# Gisborne Futures

**Phase 4** Consultation Report

**Macedon  
Ranges**  
Shire Council

Figure 4. 2023 draft housing change areas

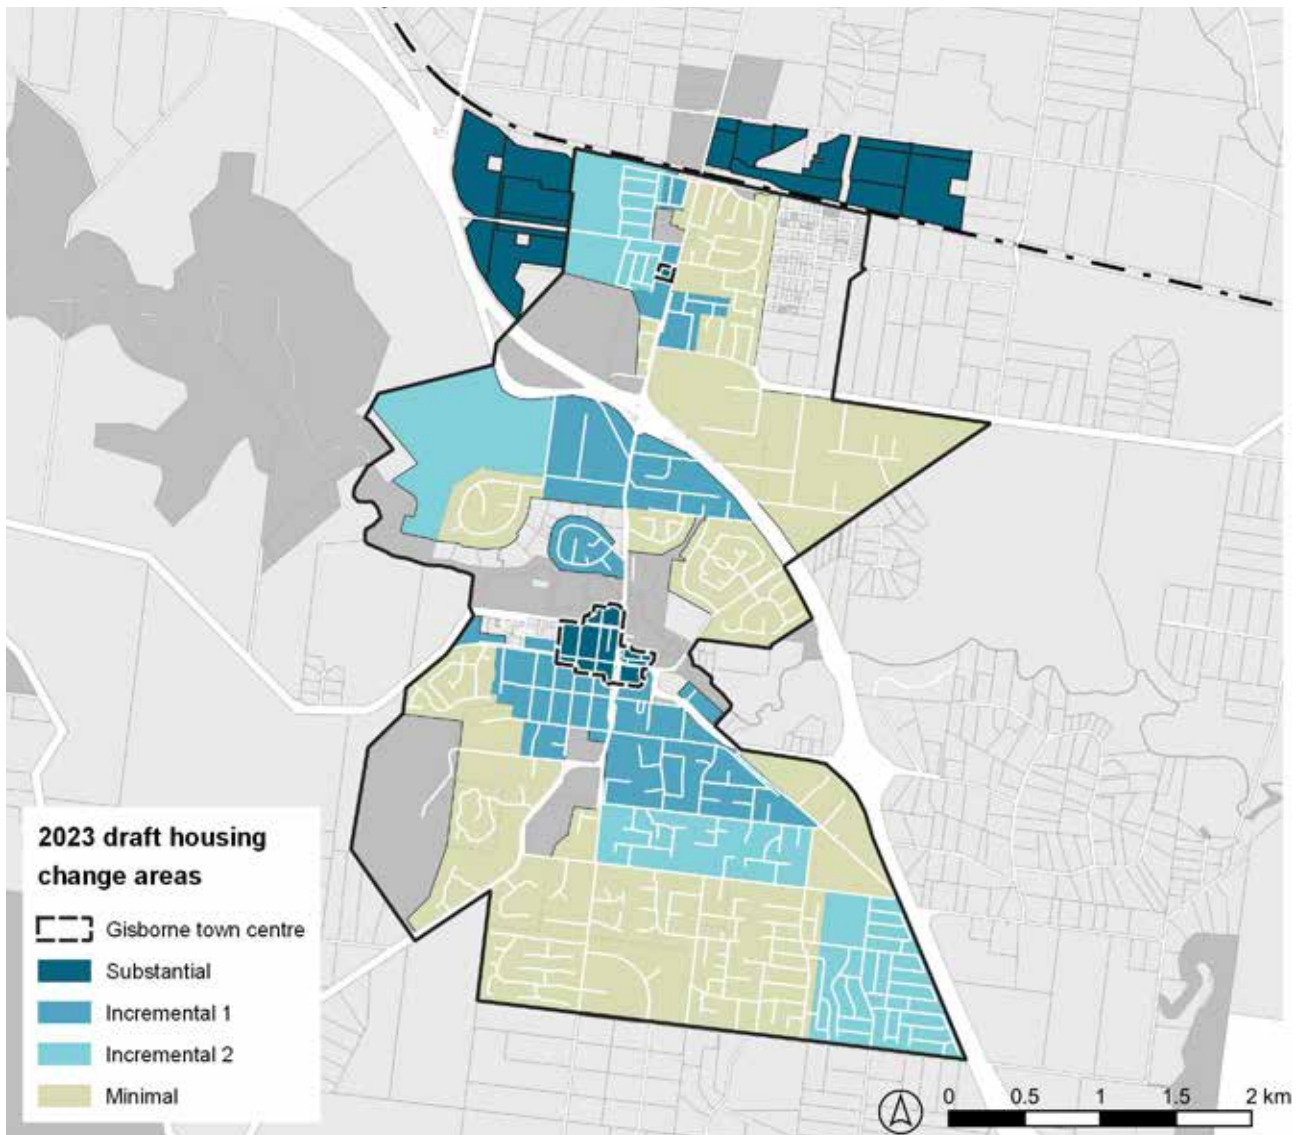
The Department of Transport and Planning (DTP) provided feedback that not all of the 'minimal change areas' meet the criteria set out in Planning Practice Note 90 (PPN90).

- provide a residential development framework plan that overlaps housing change areas with neighbourhood character types
- include brief description of each type and preferred future character
- provide a housing capacity analysis to inform the infill to greenfield ratio in housing supply.

Other submissions have asked to tighten up some of the language – the term 'semi-rural' has been used for low density and rural living areas (character area) and also for the 'semi-rural interface' in growth areas along entrance roads. The similarity of terms is confusing when the outcomes sought are different.

A revised housing framework has been prepared in response to submissions.

The 2024 change areas have been updated to better align with the criteria set out in PPN90. Key changes include:

- identification of lots on edges, interfaces and visually significant landscapes as 'minimal change'
- only applying minimal change to areas where the planning scheme specifically restricts further subdivision
- applying incremental change to any area with further capacity for subdivision (including LDRZ)
- identifying areas of substantial change around all activity centres to promote increased densities and housing diversity
